Melton Planning Scheme Amendment C147 Evidence Statement

24 November 2016

This report specifically relates to the Road Network Plan (Plan 8) contained within the Kororoit PSP which was publically exhibited in June 2016, and provides a response to several traffic related issues which have been raised by the developer.

Figure 1: MPA Plan 8 - image extract

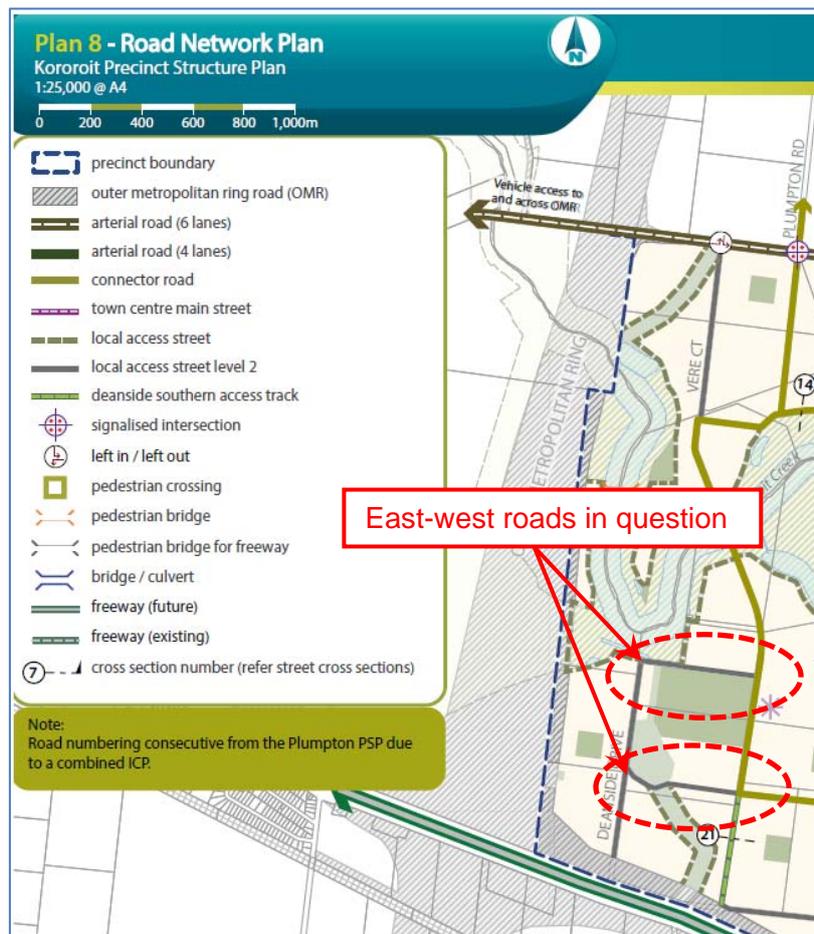
Is it appropriate for the cross section of two east-west roads located north and south of the retarding basin connecting Deanside Drive to the North South connector to be changed to Local Access 1 (16m) cross section rather than the designated Local Access 2 (20m) cross section? Refer to Figure 1.

A review of the south-west quadrant of the precinct indicates an approximate lot yield of 700 lots, with the residents of those lots expected to use the two roadways in question.

This indicates that the east-west road to the north of the Active Open space will carry approximately 890 vehicles per day (vpd), and the more southern east-west road will carry 3740 vpd.

The VPA Engineering Standards, Part C- Engineering Design Ch 10.6 – Standard Cross Sections indicates a Local Access 1 (LA1) is expected to service 1000 to 2000 vehicle movements per day while a Local Access 2 (LA2) is expected to service 2000 to 3000 vehicle movements per day.

On that basis, I am of the opinion that the cross section of the southern east-west road should not be reduced to a classification lower than a LA2 road.

There is potential to reduce the northern east-west road to LA1, perhaps with the addition of indented parking on the southern side given the proximity of the roadway to the open space. Notwithstanding my opinion I understand that an agreement has been reached between the developer and VPA to provide a roadway consistent with a LA2 cross section to the northern east-west road.

Plan 8 - Road Network Plan
Korooroit Precinct Structure Plan
1:25,000 @ A4

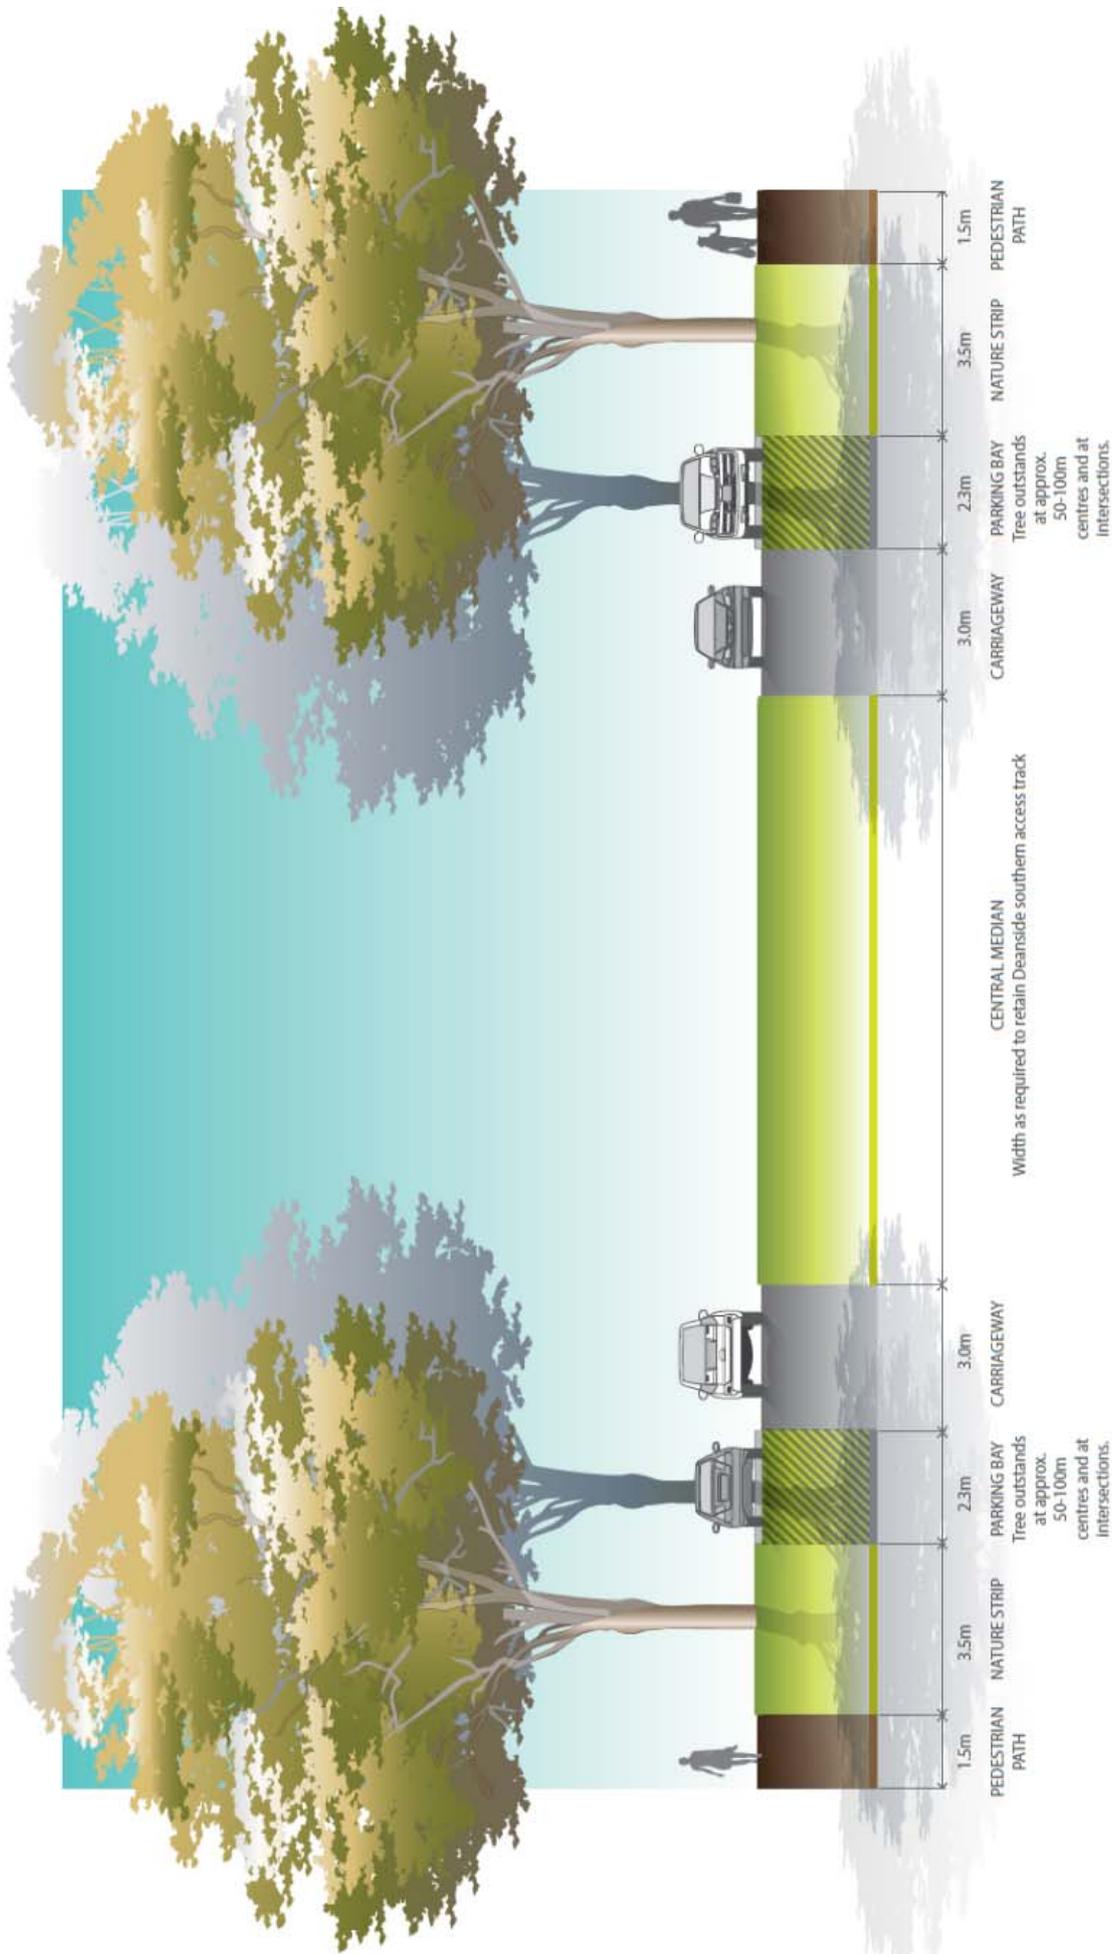
- Suitability of the proposed East-West road cross sections in the north west area of the PSP (shown as LA2 in the PSP);
- Commentary on the proposed cross section for the Deanside Southern Access Track;
- Commentary on the number and location of pedestrian bridges shown on the exhibited PSP.

PBR05 located 500m north west of the Hopkins Road bridge does not correspond with a proposed north-south path network. The nearby Hopkins Road structure and the proposed north-south collector bridge are better connected to north-south routes. I consider the PBR05 structure to be an expensive item providing low benefits to the surrounding future community.

It is noted that PBR06 and PBR07 are located 1km apart over the Kororoit Creek at the north perimeter of the proposed Kororoit Regional Park. Both proposed pedestrian bridges are centrally located connecting to parcels to the north of Kororoit Creek. These locations do not accord with a likely consolidated future path network. The installation of the two bridges rather than a single consolidated position will lock in future pedestrian desire lines independent to the proposed lineal Creekside paths.

It is recommended that the two bridges PBR06 and PBR07 be consolidated to a single location.

The proposed PBR08 and the Hopkins Road overpass of the Western Freeway are both located within the 800m catchment of the proposed train station and as such, each bridge structure is servicing the same walking catchment. It is therefore questionable as to the need for PBR08 in such close proximity to the Hopkins Road overpass. As the PBR08 exclusively services pedestrian and bicycle movements the catchment for these users is a relatively small area of the precinct so the provision of PBR08 seems to be an expensive item for low benefit.

It is recommended that PBR08 be deleted in favour of the nearby Hopkins Road overpass.

Section 22

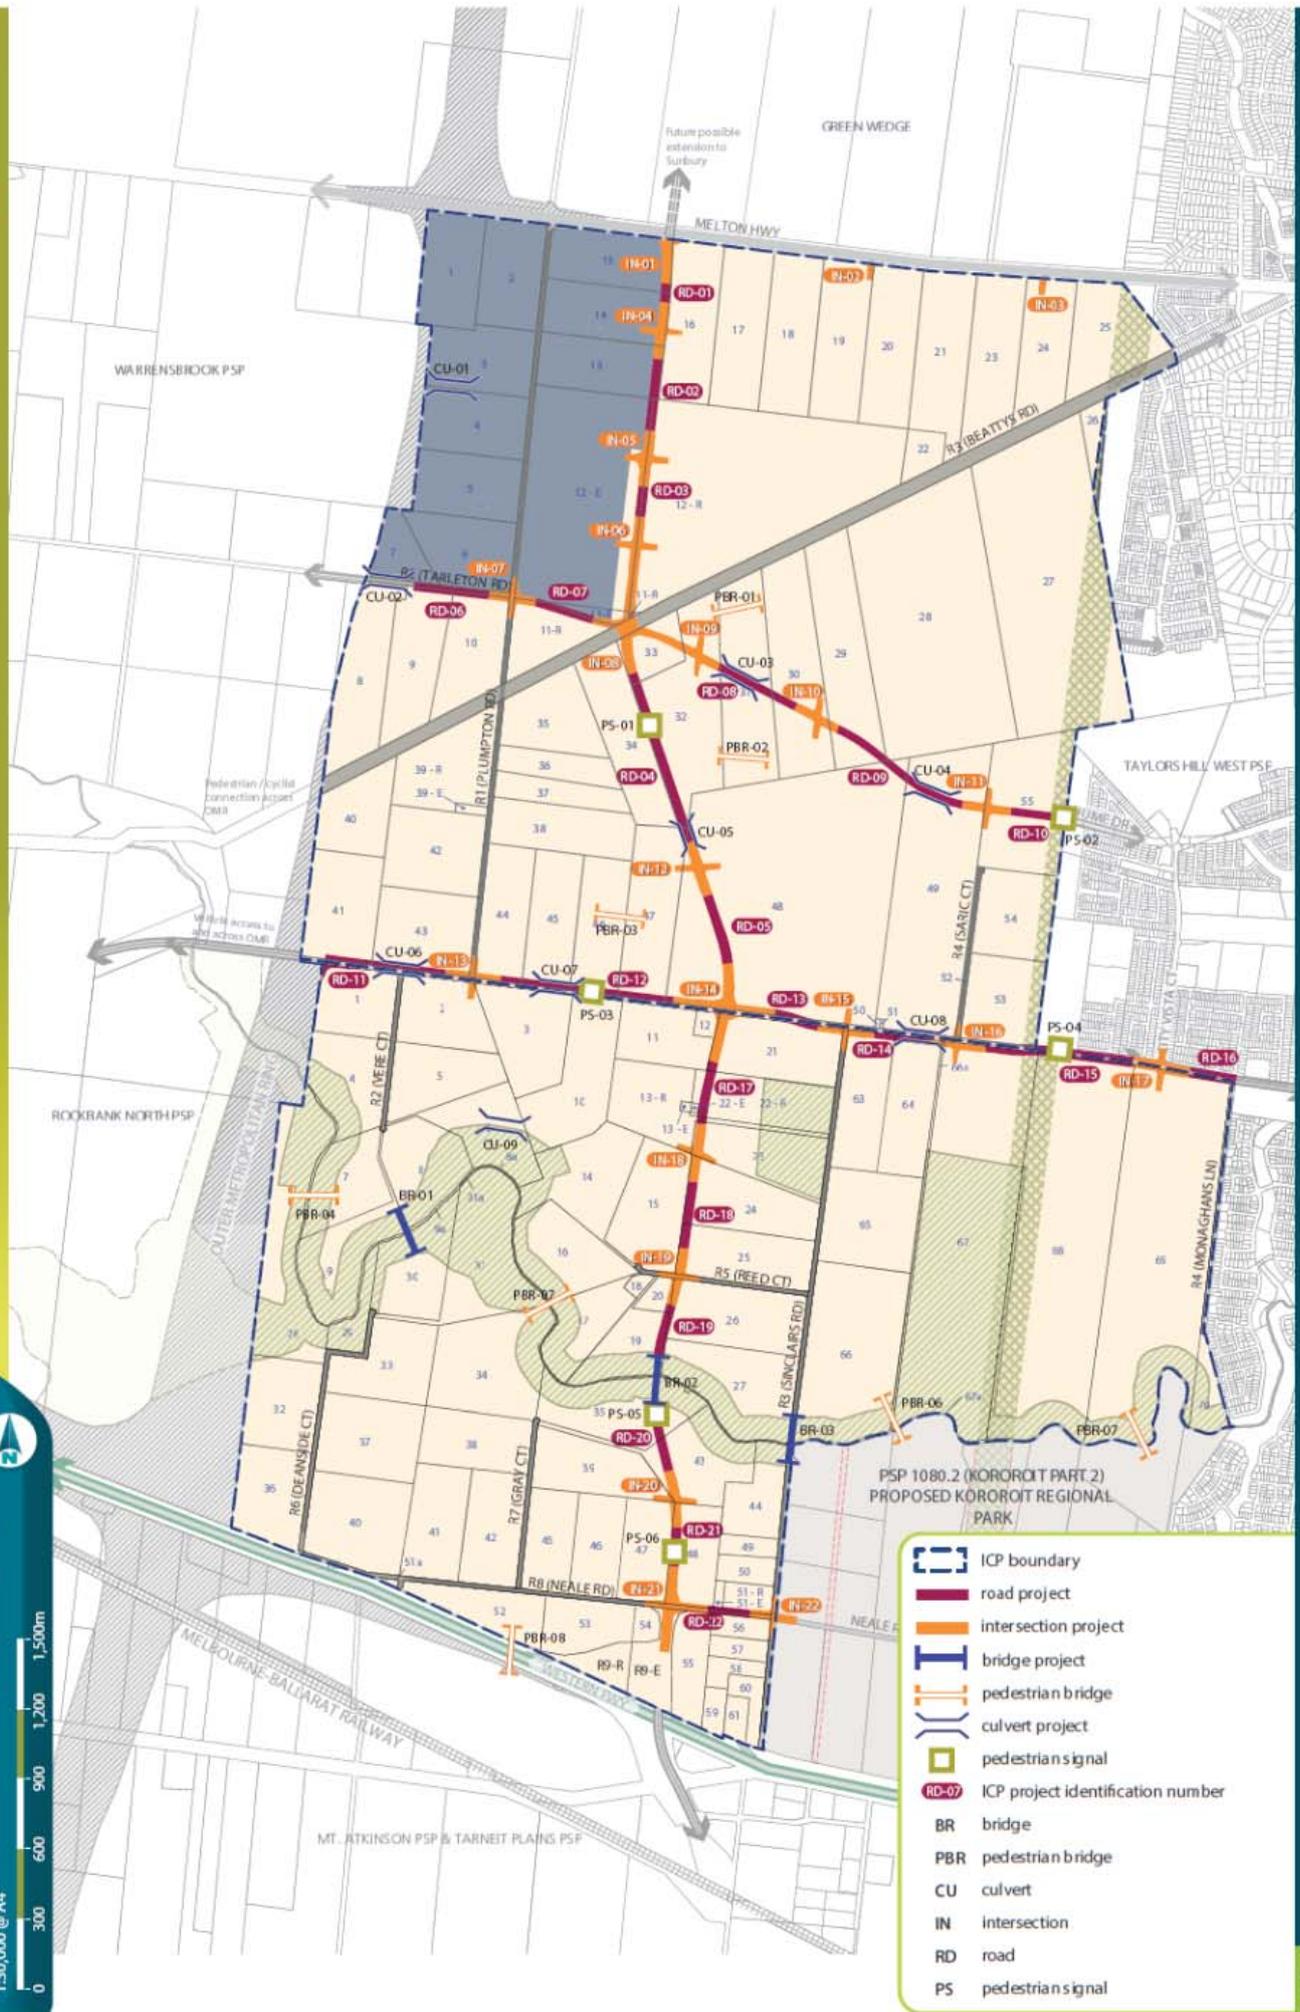
- a) *Give consideration as to whether the north-south Deanside Southern Access Track should be downgraded to LA1. It is currently shown with two separate 3.0 m wide carriageways with a 10 m central median as shown in the below extract from the proposed Section 22 – Deanside Southern Access Track.*
- b) *In assessing whether it would be appropriate for the north-south collector road north of the Deanside southern access track to be downgraded to LA1, please give specific consideration to the merits of all of dwellings alongside the southern access track being restricted to left in/left out due to the median in the proposed cross-section.*

Issue a) –The Deanside Southern Access Track can be reduced to a LA1 cross section as the predicted traffic volume for this section of road is 1360 vpd, which is at the lower end of the 1000 to 2000 vpd range.

Issue b) – There are a number of factors to consider in relation to the Deanside Southern Access Track; the width of the traffic lane, length of one way roadway and the inability to perform midblock right turn movements to facilitate access or egress.

The traffic lane width of 3m in the proposed cross section does not allow a stopped or broken down vehicle to be passed. The available passing opportunities are only available by the adjacent parallel parking and may prevent the passing movement if occupied by a parked car.

The length of the two one way carriageways will present a barrier to right turn movement afforded by the widened central median and will encourage ad hoc crossing of the median by residents, resulting in damage to the median area.

I am of the opinion that a two way two lane carriageway be considered and located to the east or west of the Deanside access track would be preferred. Those properties at the far side of the Deanside track would cross this area via a controlled / constrained lengthened driveway, thereby reducing the likelihood of damage to the widened Deanside track area. The benefits of this recommendation are:

It is noted that the identification of cross section 21 as reflecting the Deanside access track in the exhibited PSP is incorrect and the VPA have since provided a further cross section 22. Refer to Section 22 contained in Appendix B.
